Development Review (Minor) Staff Approval

8-MS-2008#3

Village at Hayden Master Sign
Program Amendment

APPLICATION INFORMATION	
LOCATION: 8220 N Hayden Rd	APPLICANT: Genna Goldberg
PARCEL: 217-12-990B	COMPANY:
Q.S.: 39-52	ADDRESS: 8390 E. Via De Ventura Blvd., Scottsdale, AZ 85258
CODE VIOLATION #:	PHONE: 480-367-7931
Request: Request to amend the Village at Hayden Master Sign Program to allow a non-contiguous wall sign band for Suite C-111 over Suite C-112, on the west elevation of the 8220 building (Building C).

EX-01

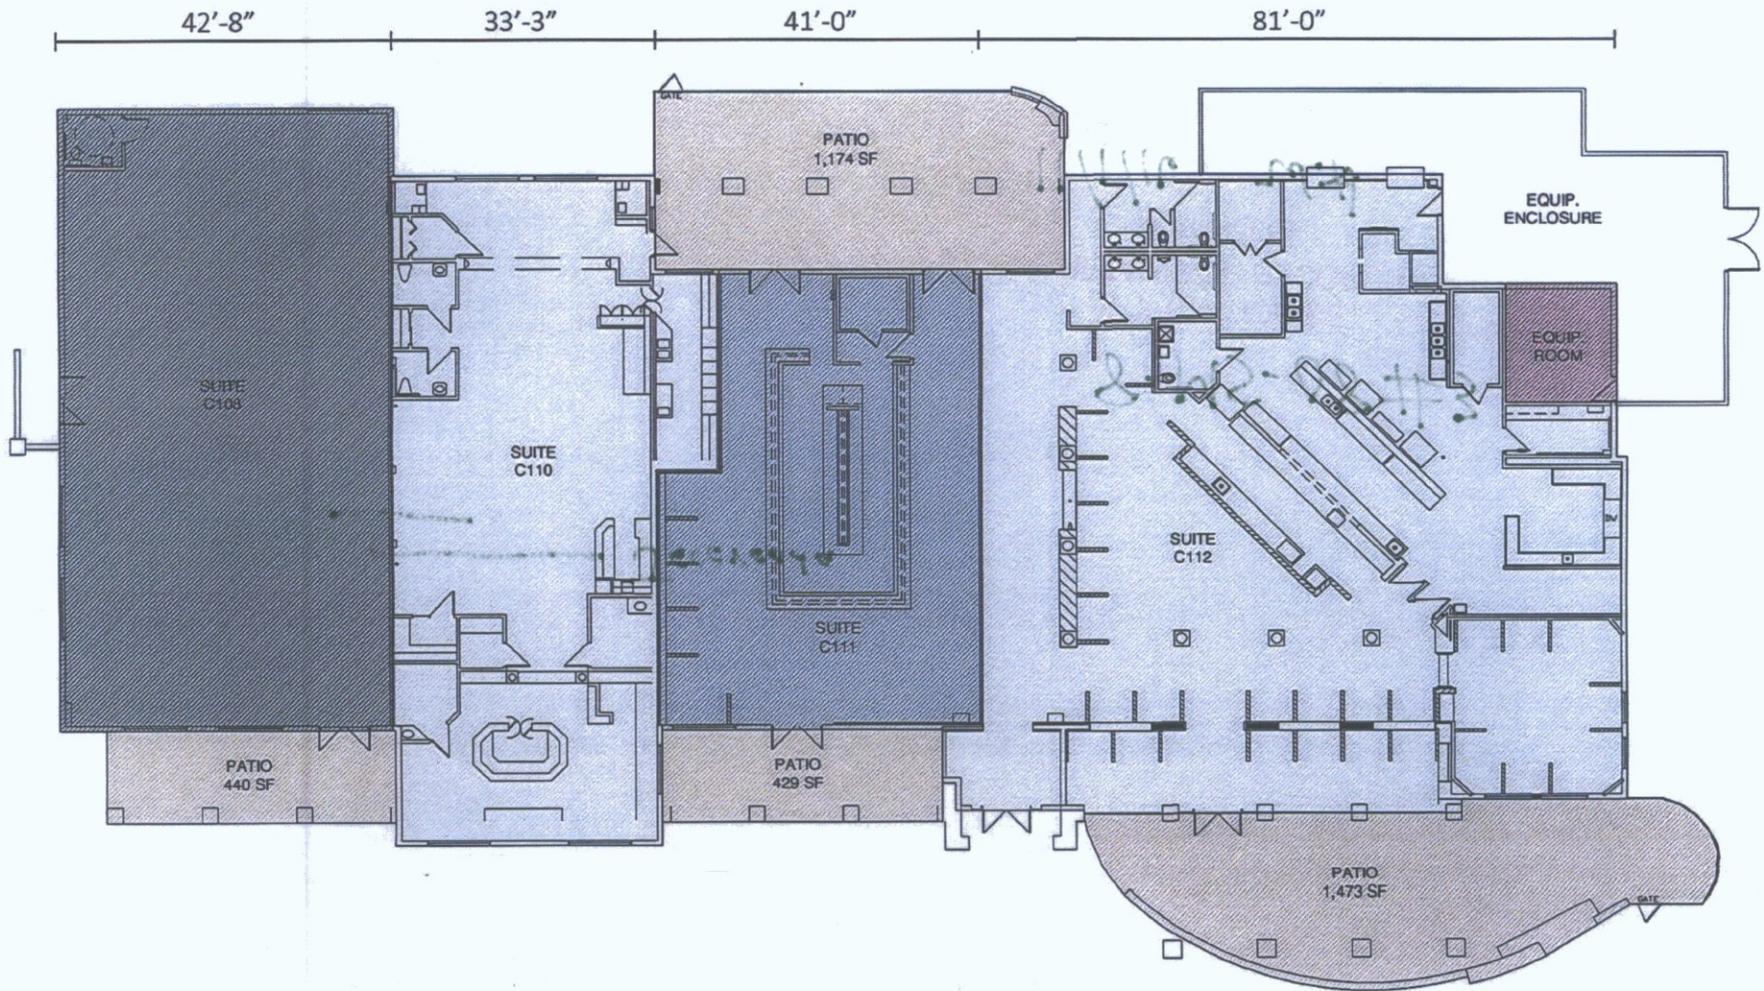
1. MSP Amendment for the purpose of establishing a Hayden Road sign band for tenant C-111 over C-112 due to the lack of a prominent building wall elevation.
2. A 24" box Jacaranda tree shall be installed, with drip irrigation provided, between Building C and the Hayden Road frontage prior to the issuance of a sign permit for tenant C-111. This is to replace a mature Jacaranda tree that was destroyed in front of the proposed sign band.
3. All other provisions of the Village at Hayden MSP and amendments shall continue to apply.
4. Any future modifications to the Village at Hayden MSP shall require Development Review Board or city staff approval.

Jacaranda tree

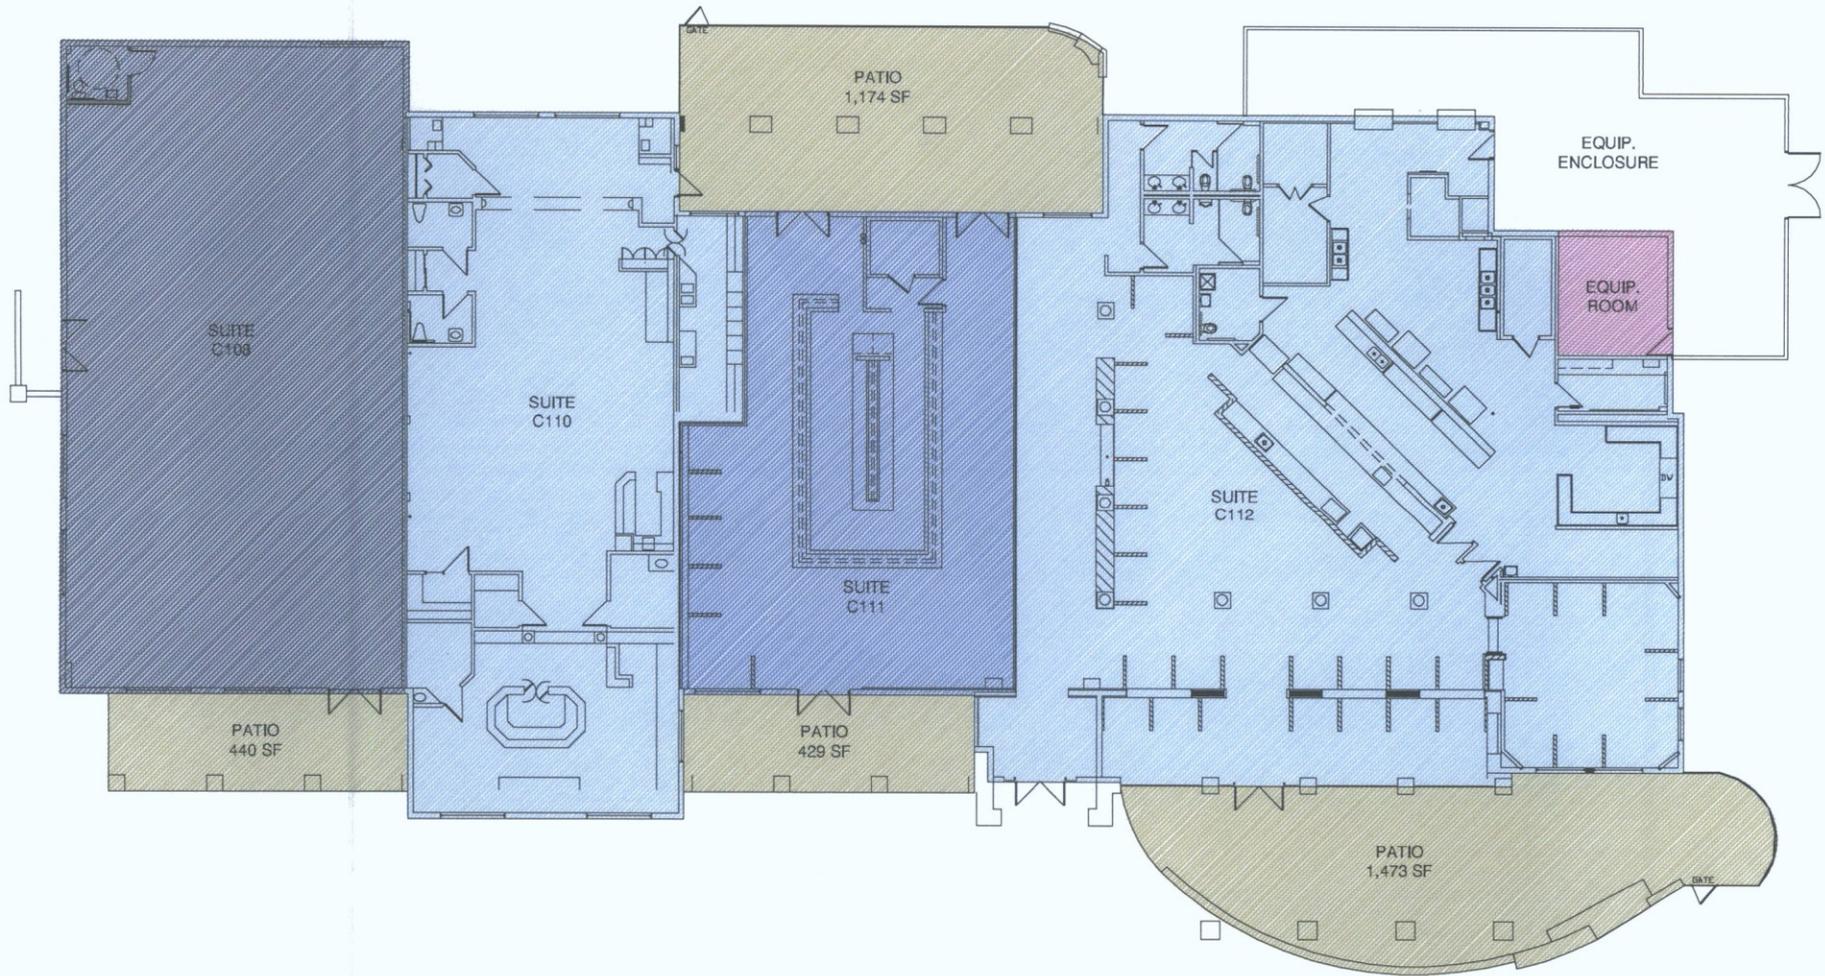
1. Please provide a dimensioned floor plan for Building 'C' that shows the linear lengths in feet for each suite along Hayden Road.
2. Provide an overall elevation for Building 'C' along Hayden Road that calls out existing and proposed sign bands and their square footages.
3. Provide a site plan that shows the location of a replacement Jacaranda or similar tree, note species and size of tree to be installed, if the tree in front of the proposed sign band has been removed. Or provide photograph existence that the tree is still in place.

Propose an alternate location and tree species if the tree was removed without city approval.

8220 N. Hayden Road

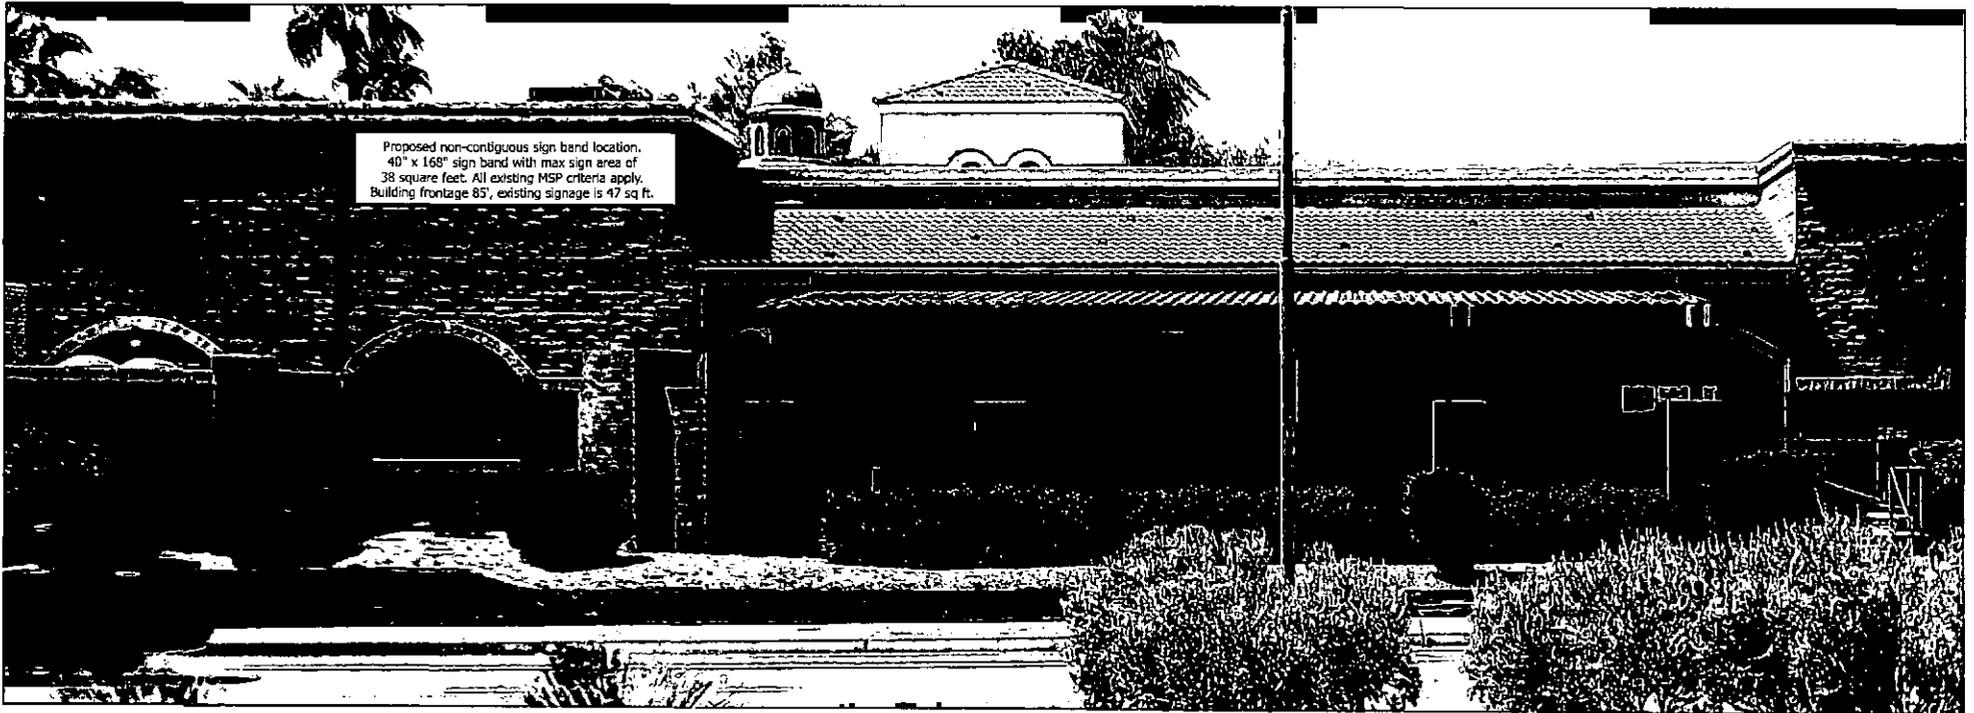
Proposed non-contiguous sign band location.
40' x 168" sign band with max sign area of
38 square feet. All existing MSP criteria apply.
Building frontage 83', existing signage is 47 sq ft.

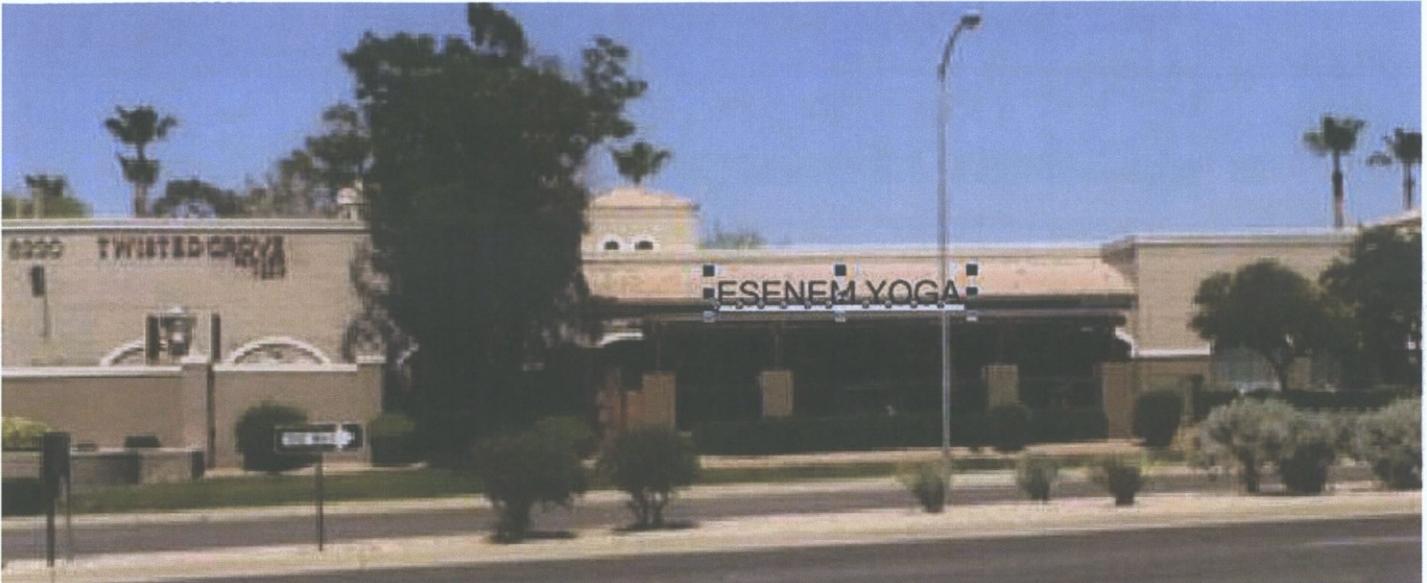
That is considered a 'standing canopy sign' and is not allowed in any zoning district other than PRC (Planned Regional Center), which is Scottsdale Quarter.

The proposed sign must either be suspended under the canopy (i.e. a 'shingle sign') or flush-mount to the wall.

I have a question – a potential client is asking for lettering on the “canopy” structure that is outside of his suite. He is looking for exposure on Hayden and this is the only space connect to his suite. I’m just wondering about the line that states it cannot go about roofline.
